HUNTER'S POND SUBDIVISION, T.I.F.
MASTER DEVELOPMENT PLAN
"URBAN DEVELOPMENT PLANING DISTRICT"
97.67 ACRES

Re: Hunter's Pond Subdivision (Amendment) **MDP # 801-B**

The City Staff Development Review Committee has reviewed the Hunter's Pond Subdivision Master Development Plan **MDP# 801-B (amendment)**. Please find enclosed a signed copy for your files. Your plan was approved for acceptance, however, please note the following conditions:

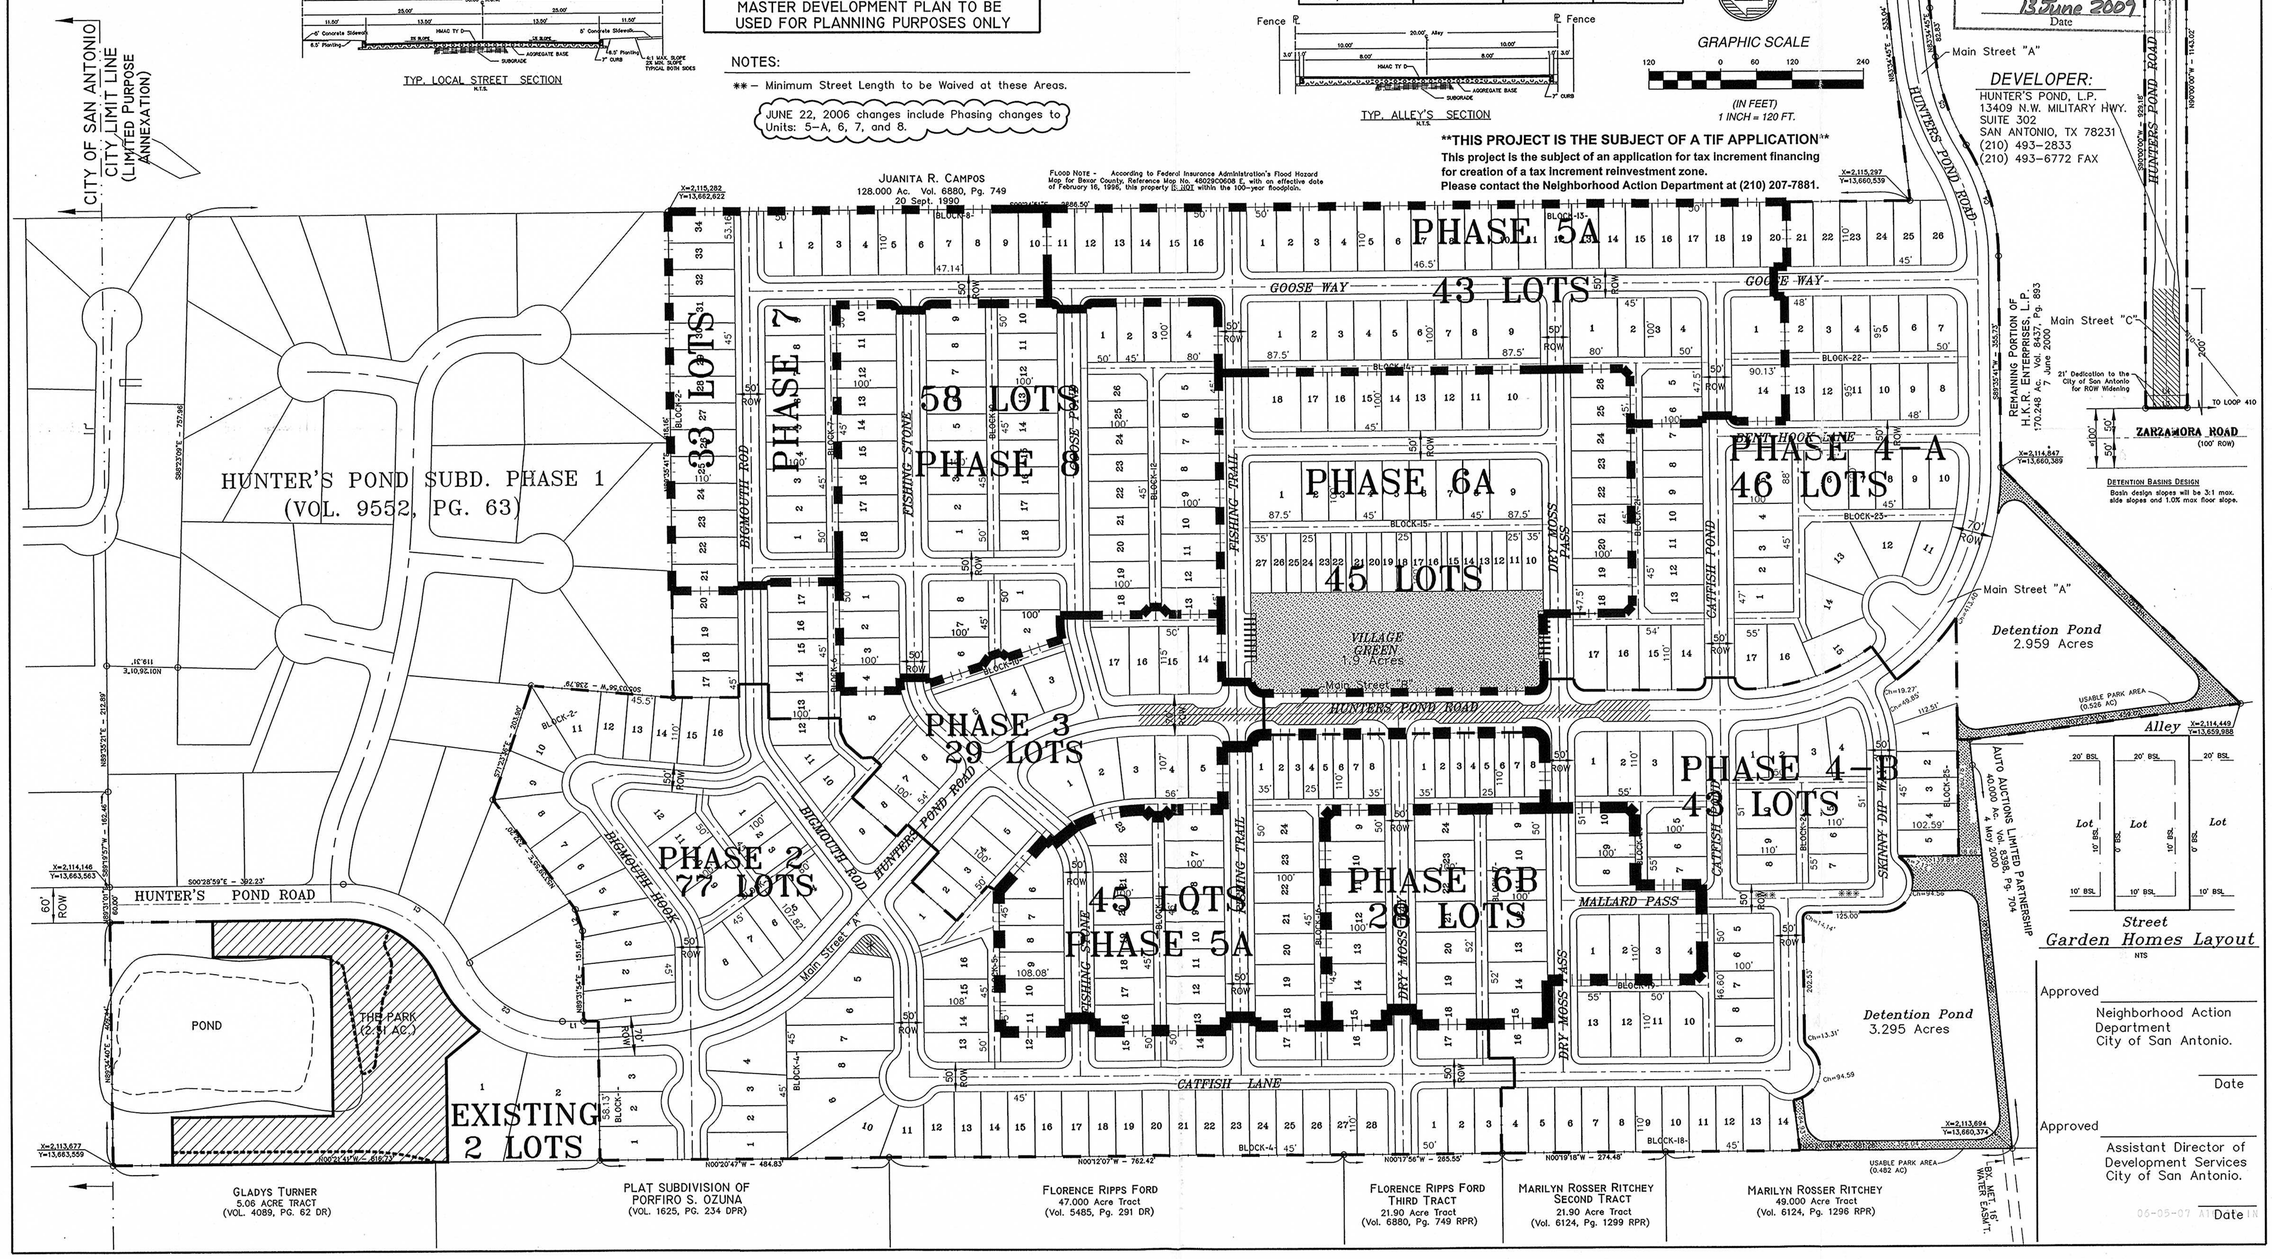
- The Developer shall provide 71 feet of ROW from the centerline of Zarzamora (Enhanced Secondary Arterial) adjacent to this proposed project.
- Construction of an internal Main Street roadway system based on Urban Development (UD)/Traditional Neighborhood Development (TND) design standards. No houses shall front on the proposed Main Street shown except where alley access is provided to such lots. This street approval is in accordance with UDC 35-506, Table 506-4 Traditional Street Design Standards.

- All Roadways shall conform to Table 506-2: Functional Classification System Description.
- Right turn deceleration lane shall be constructed on southbound Zarzamora to the proposed collector. This construction may require dedication of additional right-of-way.

- Right turn deceleration lane shall be constructed on eastbound Loop 410 Frontage Road to southbound proposed collector. The right turn lane is required based on TXDOT

Access Management Principles and Roadway Design Applications Manual. This construction will require concurrence from the Texas Department of Transportation for construction within its right-of-way.

- Hunter's Pond Road is identified as a collector with 70 feet of ROW. The configuration shown may create operational problems on the collector due to necking down to 24 feet of pavement.

- Plans shall indicate ROW on Zarzamora. Enhanced Arterial ROW shall be 142 feet. Developer shall provide 71 feet of ROW from Centerline of Zarzamora.
- Intersection sight distance should be used for all intersections.
- It is understood that this MDP is a conceptual plan and all regulations will be addressed at time of platting. Bexar County reserves the right to address driveways, street design, sight distance, ADA requirements, drainage and floodplain issues at time of platting.
